DESIGN REVIEW COMMITTEE

October 16, 2024 6:00 PM

PLANNER'S REPORT

RE: Design Review Application - 3361 Dogwood Drive, façade renovations

**CURRENT &
PROPOSED IMAGES**

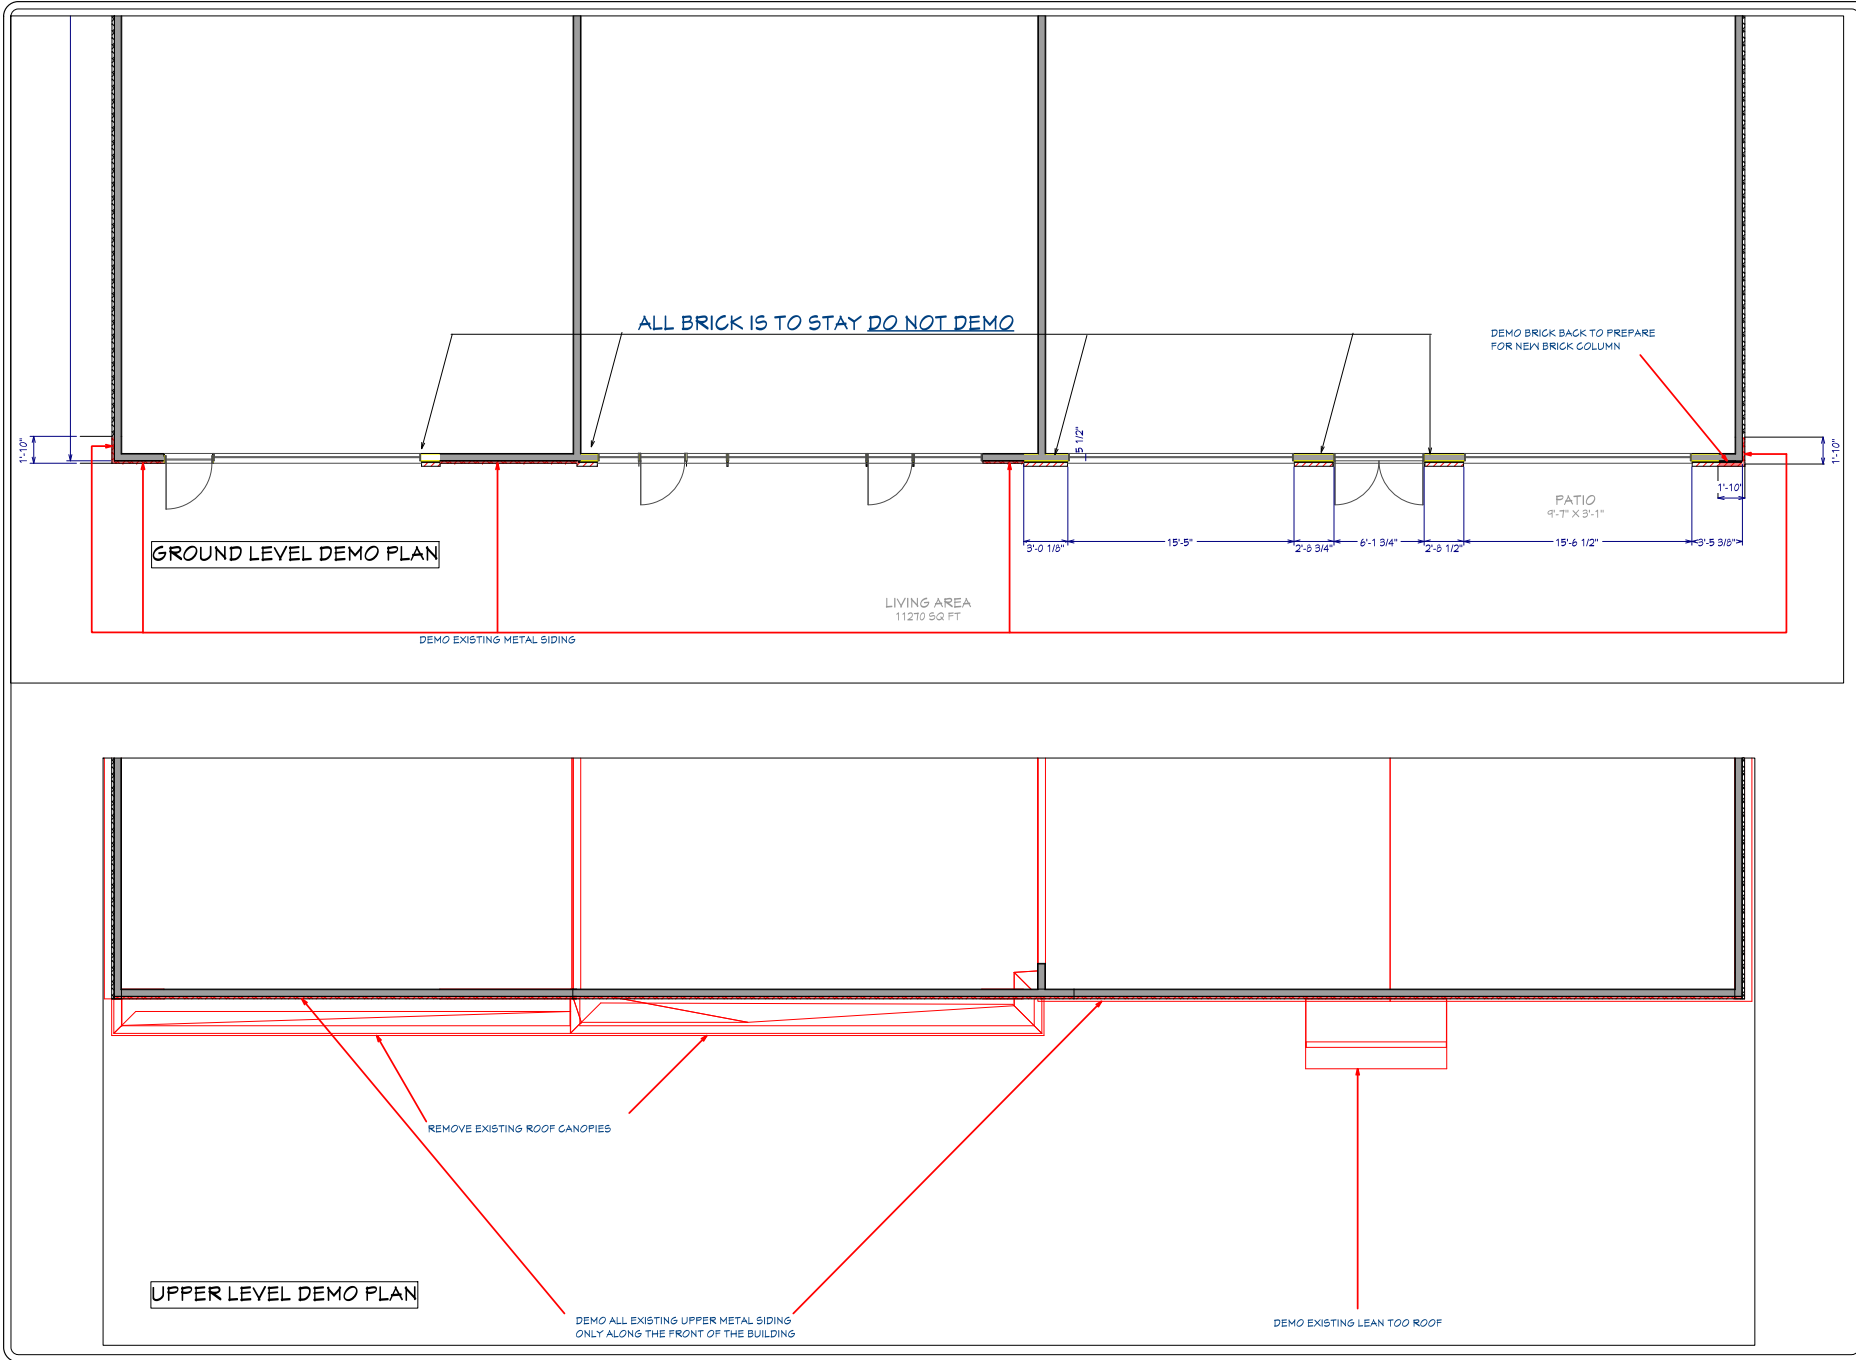
Brick does not appear to be continued to side façade for first 20'.

NOTES: *The main entry door opens directly into the existing parking lot. There is no dedicated walkway from the front door to the sidewalk adjacent to Dogwood Drive.*
Awning style is different than ADS. Provide depth dimension.
Building numbers are not provided adjacent to the front entrance.
Existing windows to be maintained. Recess unknown. No transom is located above the windows. Recommend Design Exception for windows.
Window tint, if used, must be compliant.

- Any mechanical visible from the right of way must be screened.
- A dedicated walkway should be considered from the entry doors to the sidewalk.
- Building numbers should be provided adjacent to the front entry.
- Ensure window tint compliance and window recess
- Show gutters and downspout material and location.
- Consider extending brick along side façade for first 20'.
- Provide depth dimension for awning.

PROPOSED SITE PLAN

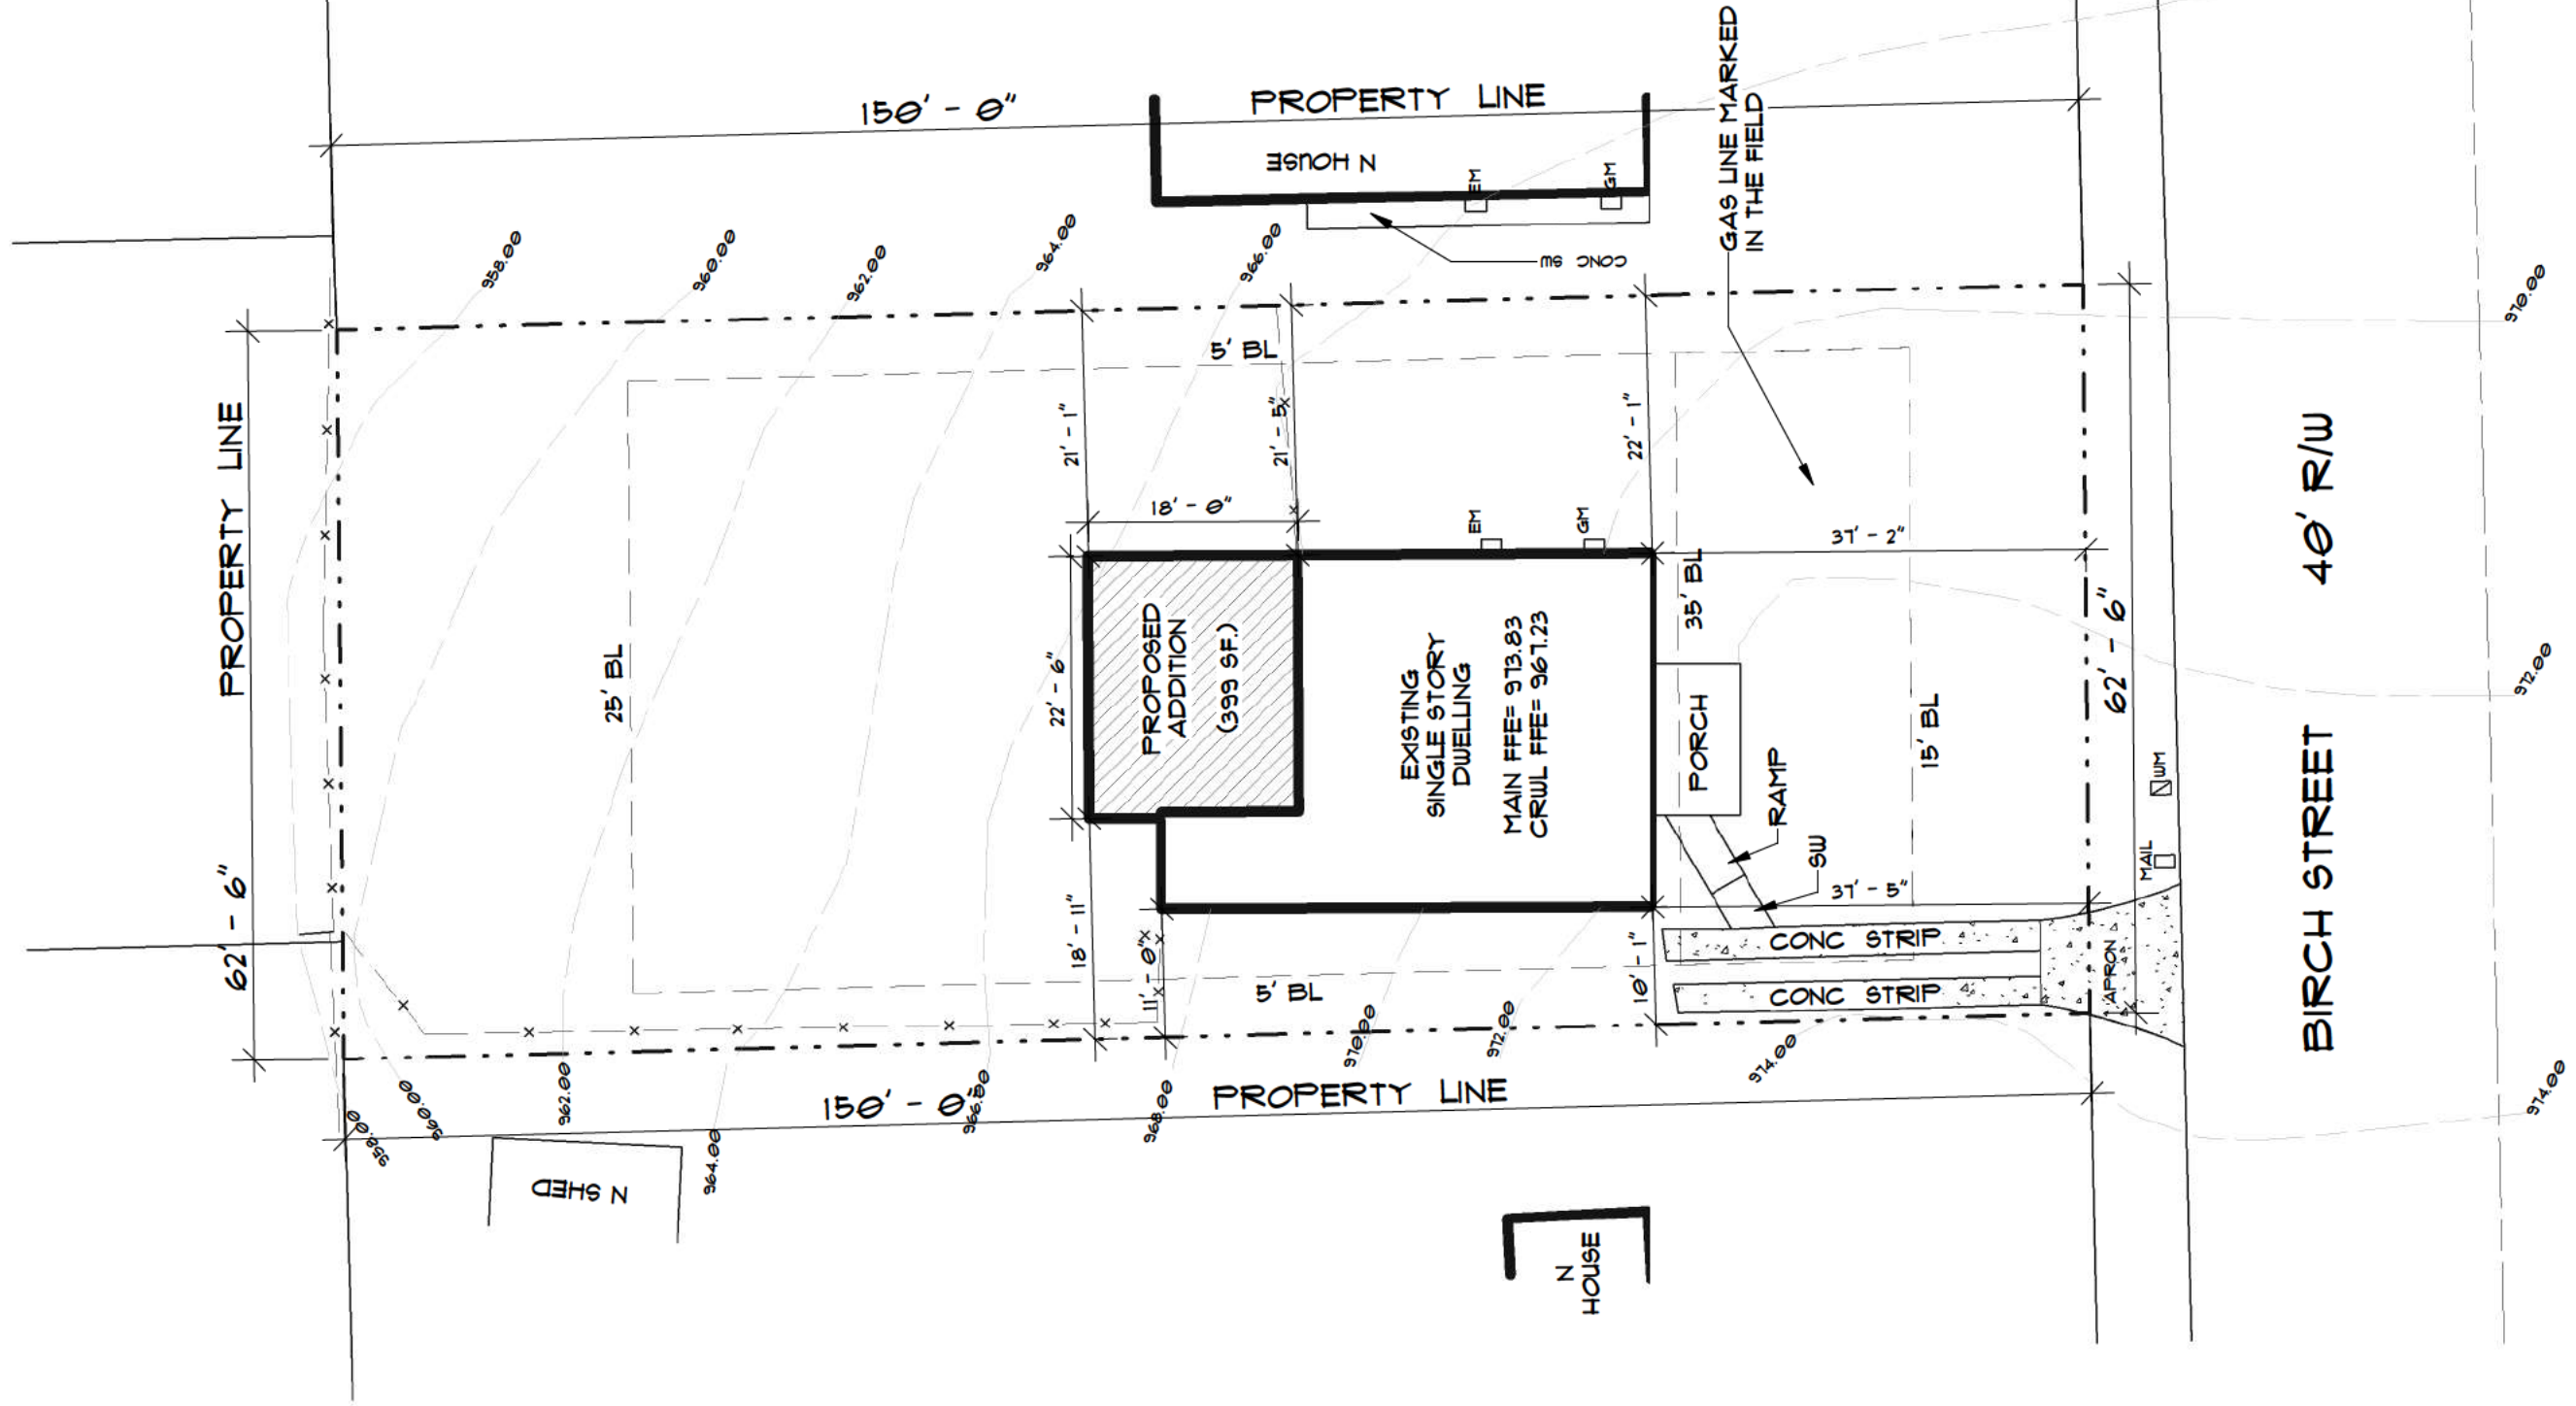
STAFF COMMENT: There is no sidewalk in front of the house. There is an existing sidewalk across the street (see below for evaluation criteria). Design Exception Recommended.

STAFF COMMENT: Two concrete strips for the driveway end in the front yard. If topography allows, it is recommended to extend the driveway past the front façade of the house to allow for parking along side the house instead of limiting to the supplemental area.

4 (N) FRONT ELEVATION
1/8" = 1'-0"

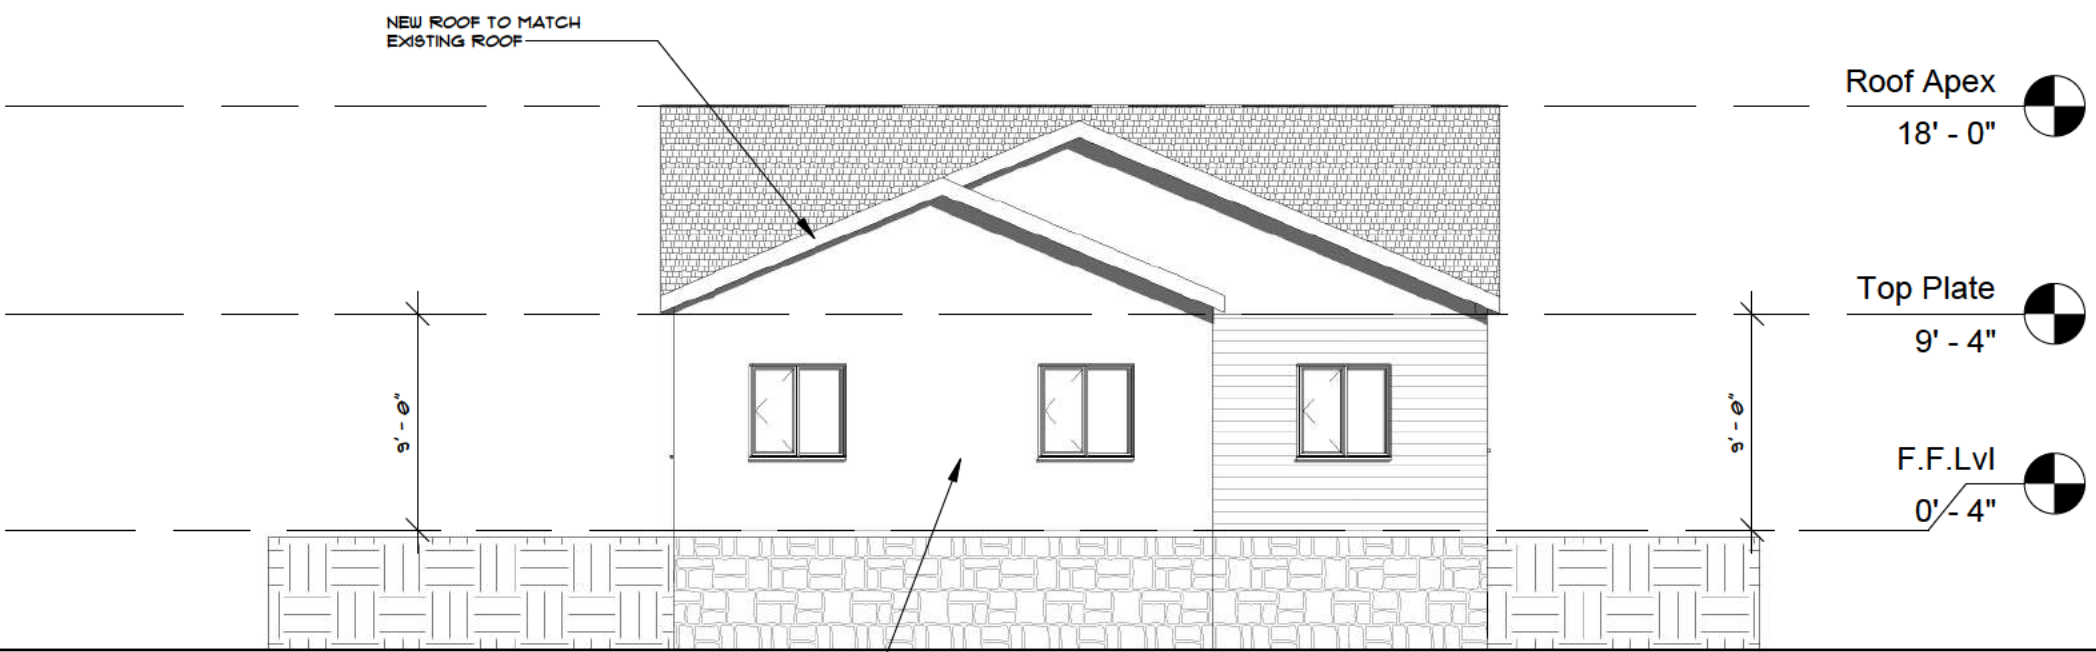
STAFF COMMENT: No detail is provided for the roof warranty. No gutters or downspouts are detailed. The roof overhang dimension has not been provided, existing house does not have an overhang. If planning to match, design exception required.

Porch is not included in any renovation. Dimensions of porch have not been provided. If not change, design exception recommended.

STAFF COMMENT: A path from the front door to the street has not been provided. The construction set has no window or trim and sill detail. Windows appear to be casement on all sides which is different than current. Unclear if all windows will be replaced and if so, recess should meet standards as well as trim and sill.

- **Window, trim and sill detail. Please provide. If all windows will be replaced, recess should meet standards as well as trim and sill.**
- **A path from the front door to the street (in lieu of sidewalk).**
- **Front porch dimensions.**
- **Roof warranty.**
- **Gutters or downspouts detail**
- **Roof overhang dimension. Existing house does not have an overhang. If planning to match, design exception required.**
- **Gutter and downspouts detail.**
- **Location of mechanical and any screening if visible from ROW.**
- **Light at front door.**
